#2012-91
73 Lincoln Parkway (Harkins)
Project Review for Planning and Zoning Commission

Meeting Date: September 5, 2012

73 Lincoln
Parkway garage

NEW SITE PLAN
SCALE 1:20

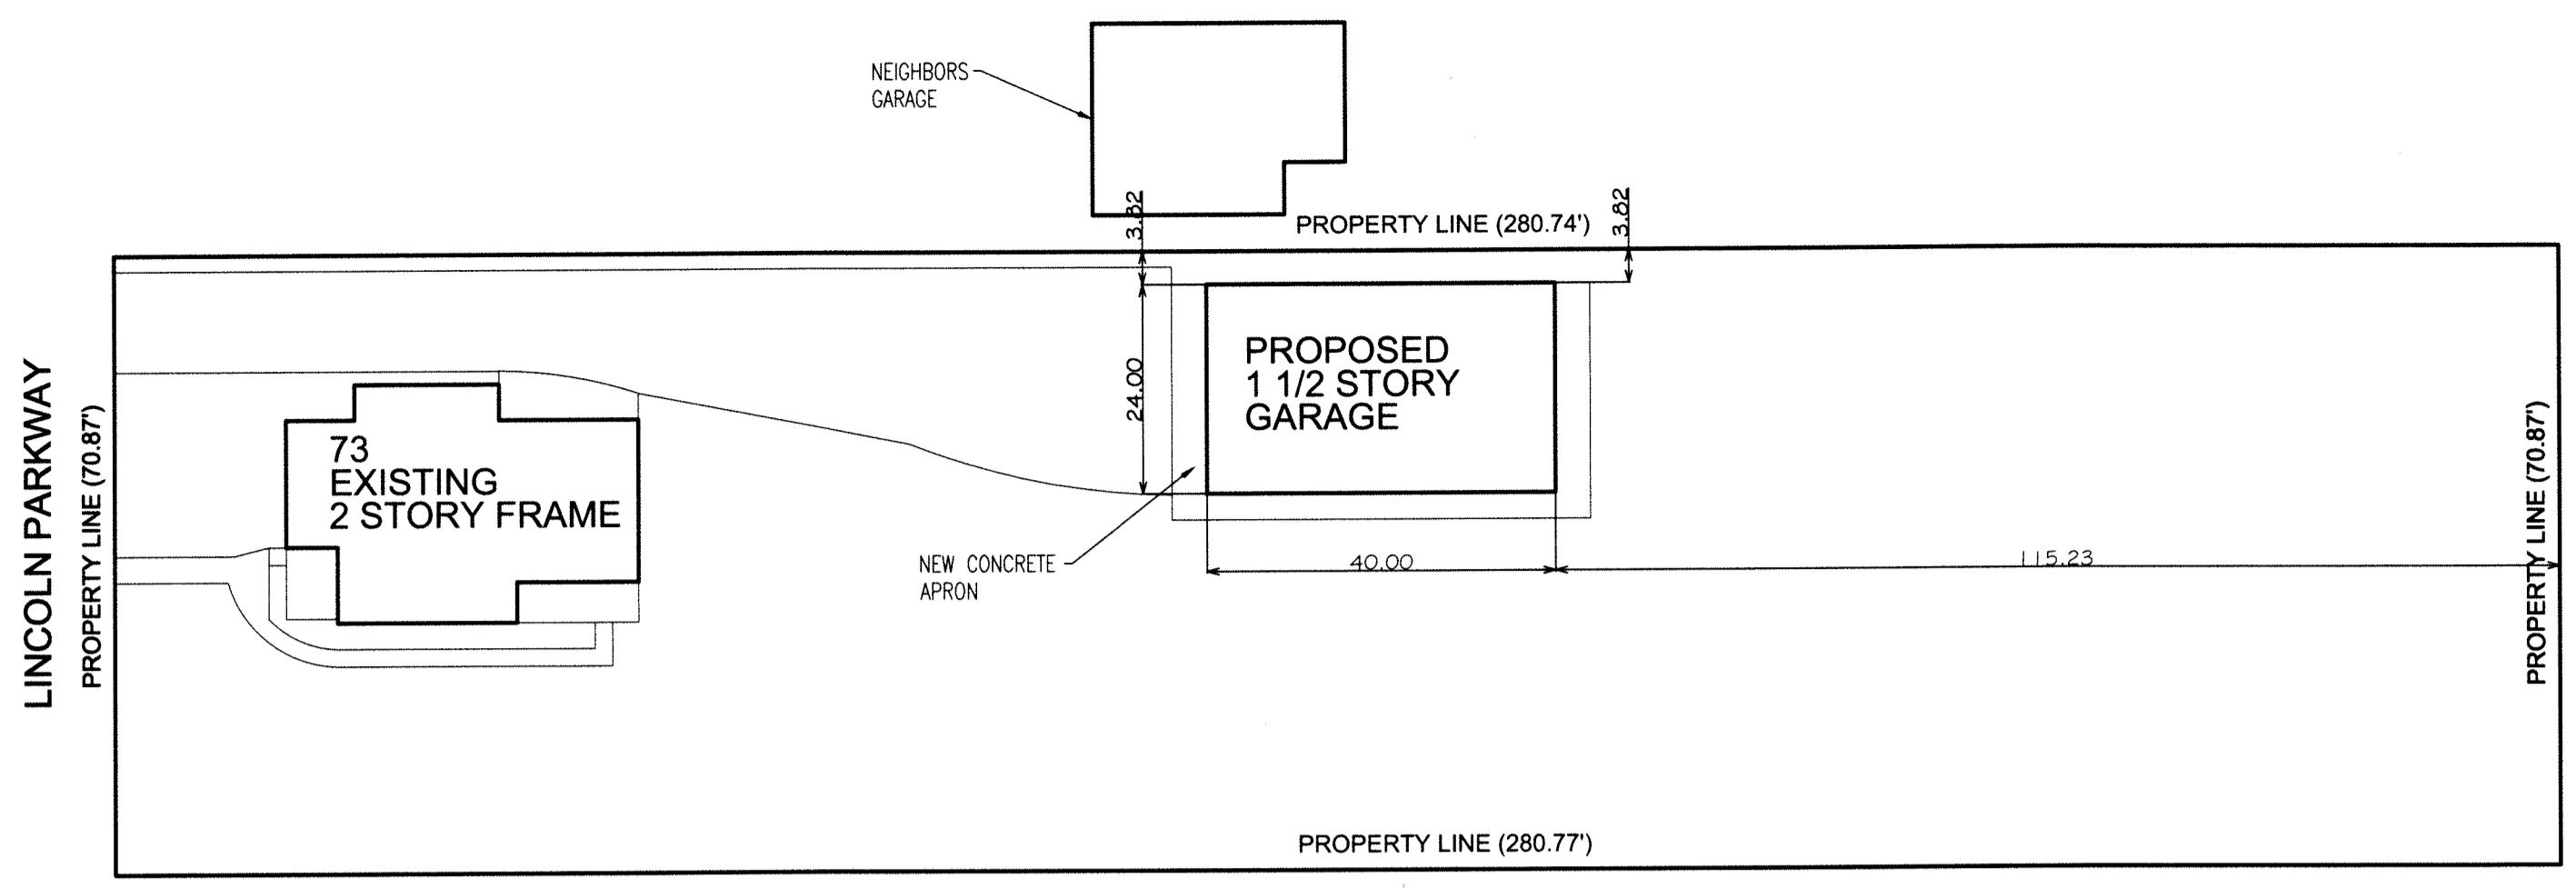
- Accessory structures are required to be a minimum of 5 feet from any rear or side property line. The existing garage is only 3.82 feet from the side yard property line. Since the existing garage will be removed any existing non-conformity is lost. The new garage should meet the required setbacks.

6. The north wall of the garage shall be 1-hour fire rated. New ventilation for the second floor is required as eave vents are not permitted
7. The petitioner shall comply with all of the requirements of the Engineering and Building, Fire Rescue, Public Works and Planning and Economic Development Departments.

A3
CONCRETE

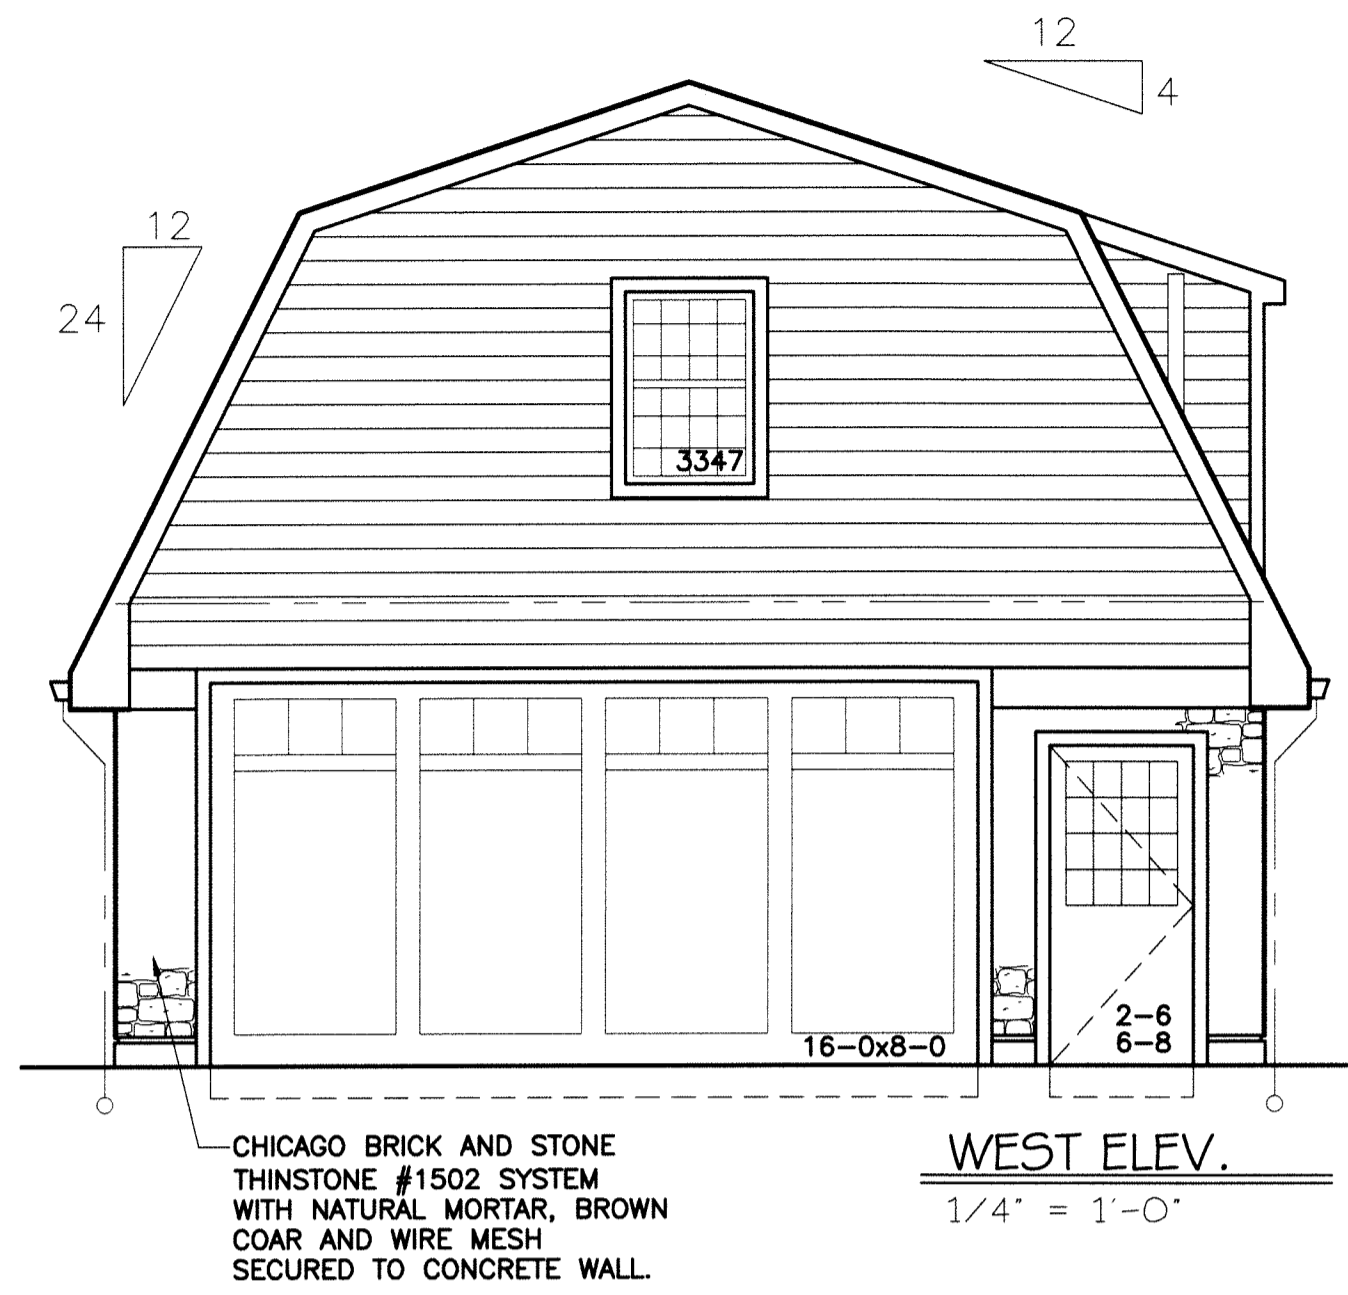
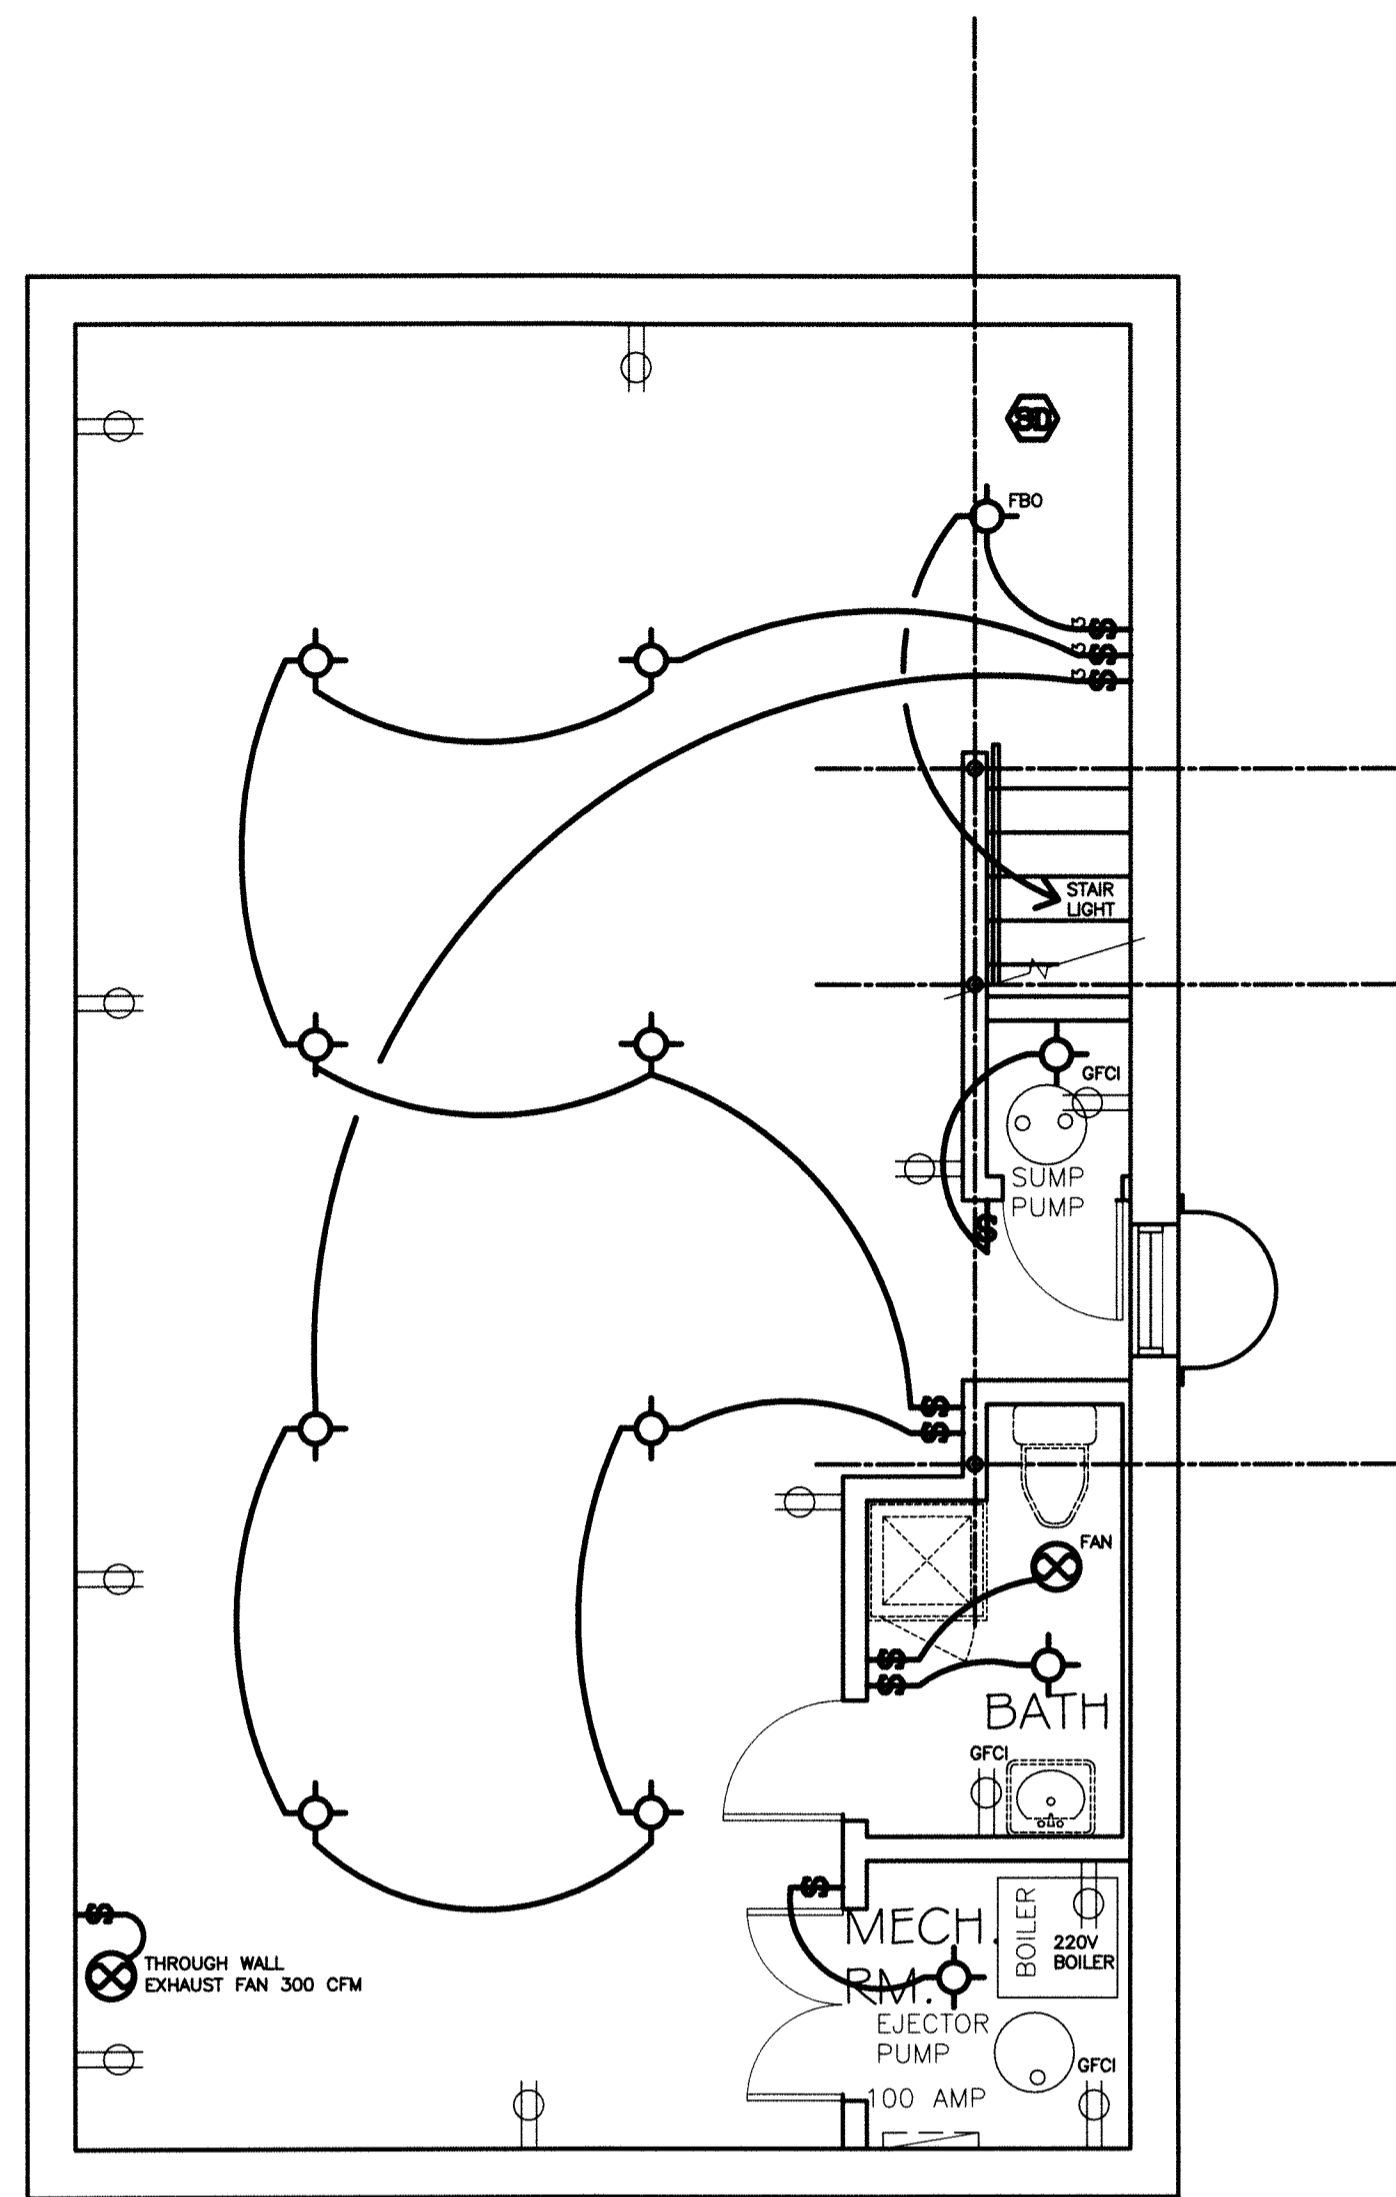
- Accessory structures are permitted to have a continuous dormer at a length not to exceed 20% of the structure's side length. In this case, that would be 8 feet.
- Accessory structures can have up to two dormers for a total length not to exceed 40% of the structure's side length. This would allow two dormers at a total of 16 feet.
- If the dormers are separated into two dormers and the center portion removed, it would meet ordinance requirements. A condition of approval to this affect has been added.

- Stories are measured based on the height of the wall plates. Any wall plate over 4 feet in height constitutes a story. With a gambrel roof, the wall plates are only about a foot high for the upper floor, therefore, this structure is only one story in height.

4. The dormer should be split into two dormers, not exceeding 8 feet in length each, for a total of 16 feet of dormer area.
5. The garage shall not be located within any Public Utility Easement, Municipal Utility Easement or Public or Private Drainage Easement.
